Drinking Water Audit Report

County:	Co. Louth	Date of Audit:	11/07/2019
Plant(s) visited:	Greenmount Water Treatment Plant	Date of issue of Audit Report:	25/07/2019
	Scheme Code 2100PUB1002	File Reference:	DW2019/122
		Auditors:	Ruth Barrington Daryl Gunning
Audit Criteria:	The European Union (Drinking Water) Regulations 2014 (S.I. 122 of 2014), as amended

Photo 1. Flocculation tank at Old Plant showing build up of floc/ algal material on tank walls.

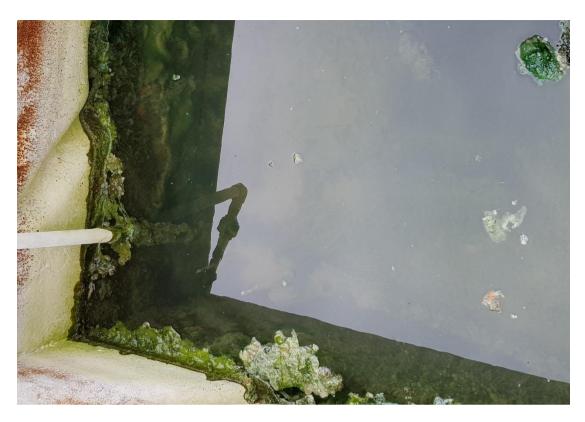
- b. The flocculation tank was found to have a large amount of floc/ algal build up on the walls (refer to Photo 1. This may indicate that floc is forming and dropping out within the tank rather than remaining in suspension until it reaches the clarifier. The structure of the tank means that routine cleaning is difficult as there is no proper access to all sides of the tank.

- 6. Irish Water should optimise the CFC processes at Greenmount Water Treatment Plant, including the following considerations:
 - a. For coagulant and polyelectrolyte dosing, the dose location, contact time and current lack of mixing post-dosing should be addressed.
 - b. For all stages in the CFC processes, the cleaning and maintenance of tanks, channels and working platforms to be addressed, to prevent the build-up of floc, sludge and algae which was being carried over into clarifier channels during the audit.
 - c. For both Old and New Plants, the design flow and operational flow through the plants to be optimised to ensure the loadings are appropriate and within the design capacity.
